## **Historic Landmark Commission Meeting Agenda**

**Tuesday, January 20, 2026**

**a.** Discussion and action on a Certificate of Appropriateness for 602 Washington St.

**Floor Plan & Dimensions**  
 Itlis Pioneer Homestead Addition & Remodel  
 905 Lisbon  
 Castroville Texas 78009

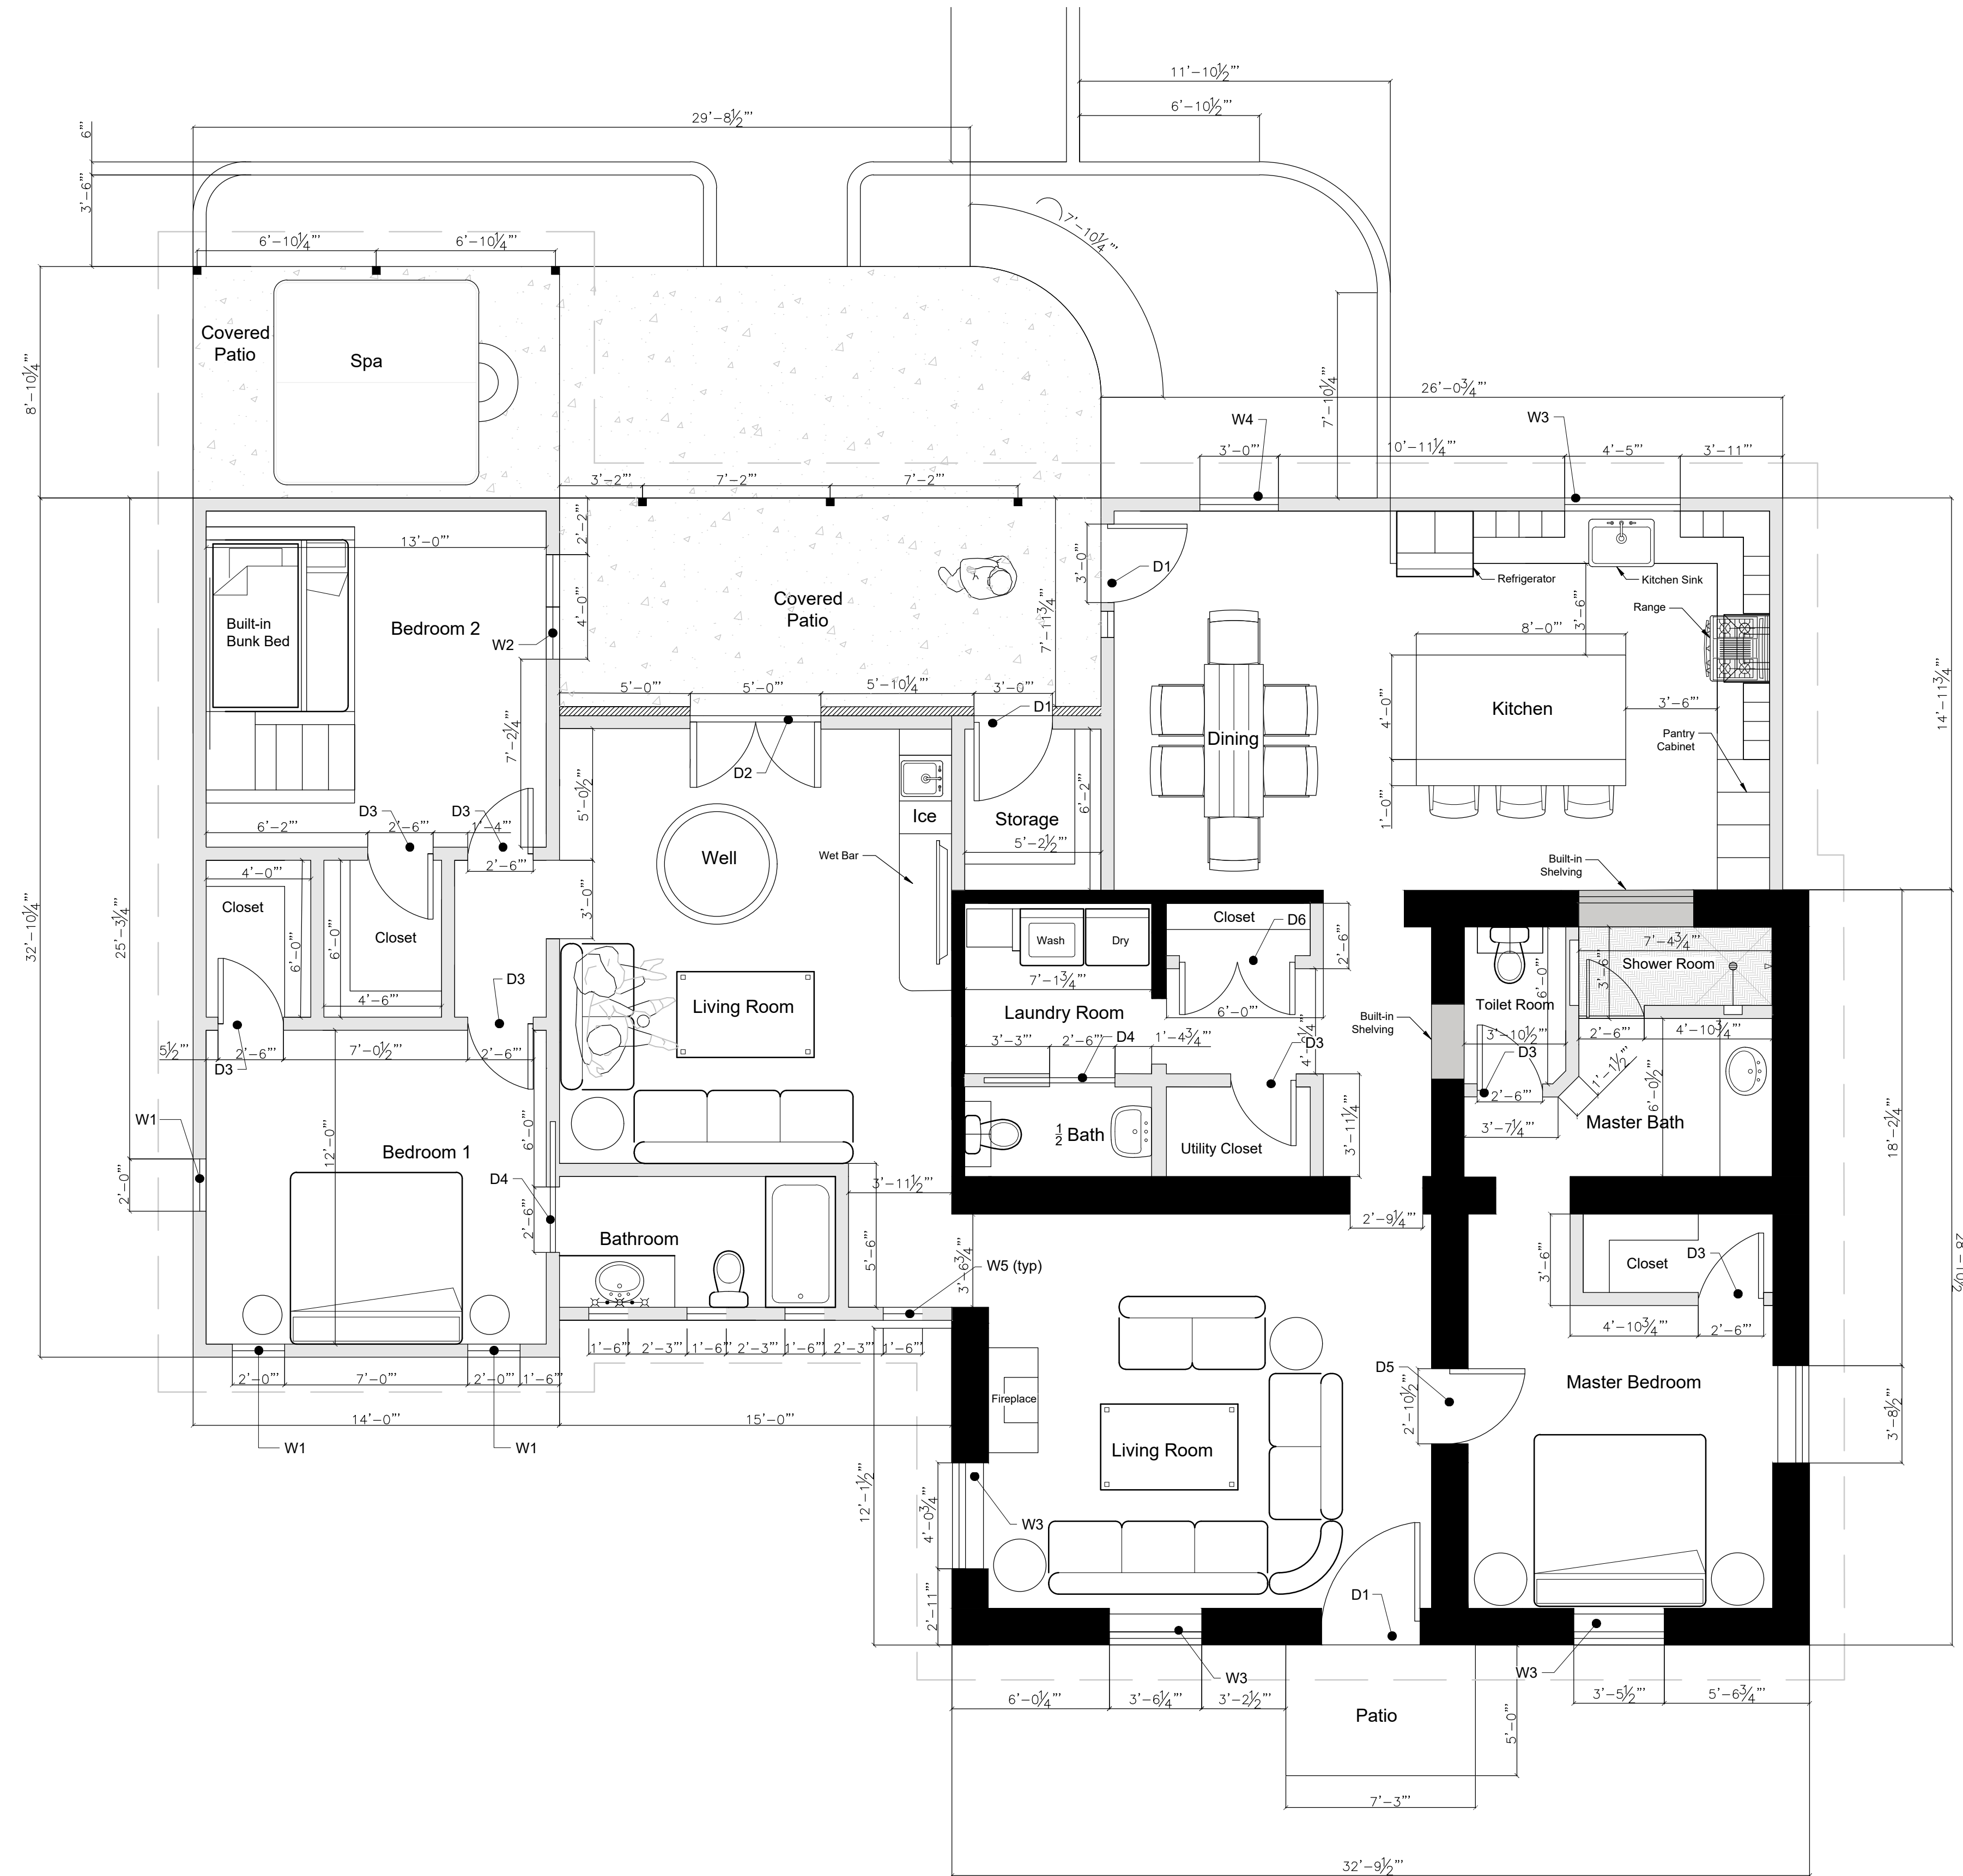
1. Per the Castroville Design Guidelines, Section II, Siding and Wall Surfaces (pg. 23), removal and/or covering of historic material and architectural features contribute to a significant character loss for a building, minimize its historic integrity and diminish its appeal. On the southwest façade, the applicant is proposing to remove the windows on the saltbox section of the home. *It is recommended that the addition be added to the back of the home to avoid losing these features.* Note that the applicant has presented the proposed design to avoid removing the large tree at the back of the home and to incorporate the well into the floor plan.

3. Per the Castroville Design Guidelines, Section II, Fences and Walls (pg. 38), *many landmark properties have large old trees that should be conserved where possible. In particular, live oaks and pecan trees should be protected and preserved.* Note that the applicant has presented the proposed design to avoid removing the large tree at the back of the home and to incorporate the well into the floor plan.

4. Per the Castroville Design Guidelines, Section II, Fences and Walls (pg. 39), scattered throughout the historic district are miscellaneous details such as *wells*, water cisterns, windmills, barns or outhouses. The Commission encourages you to preserve these details. You will need approval from the Commission if you wish to construct, replace, remove or modify them. Note that the applicant has presented the proposed design to avoid removing the large tree at the back of the home and to incorporate the well into the floor plan.
